ED-MONITOR-156C

PCN

Product Change Notice 1

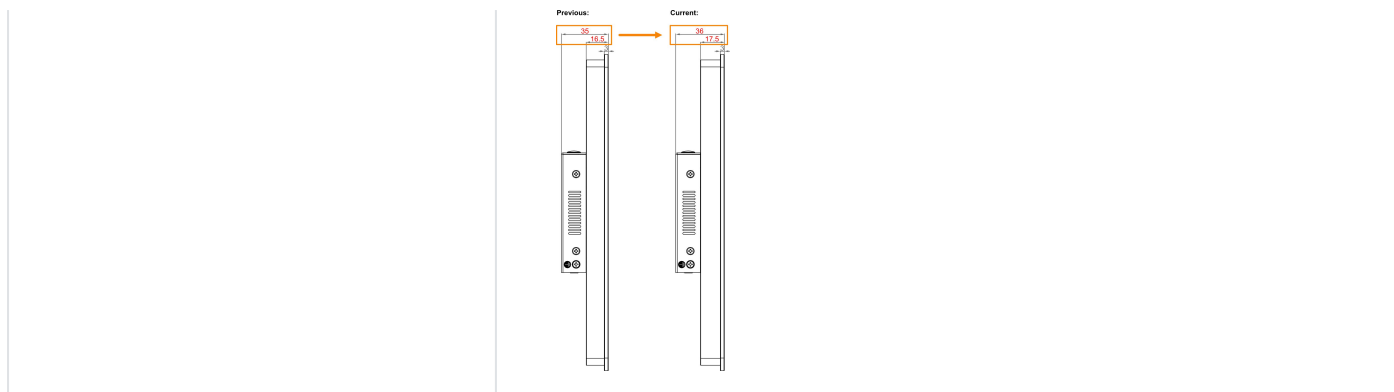
Changes	Results
LCD bezel thickness increased by 1mm	We have optimized the LCD bezel structure to provide additional clearance for internal cable routing. - LCD bezel thickness: adjusted from 16.5mm to 17.5mm. - Total product thickness: correspondingly adjusted from 35mm to 36mm.
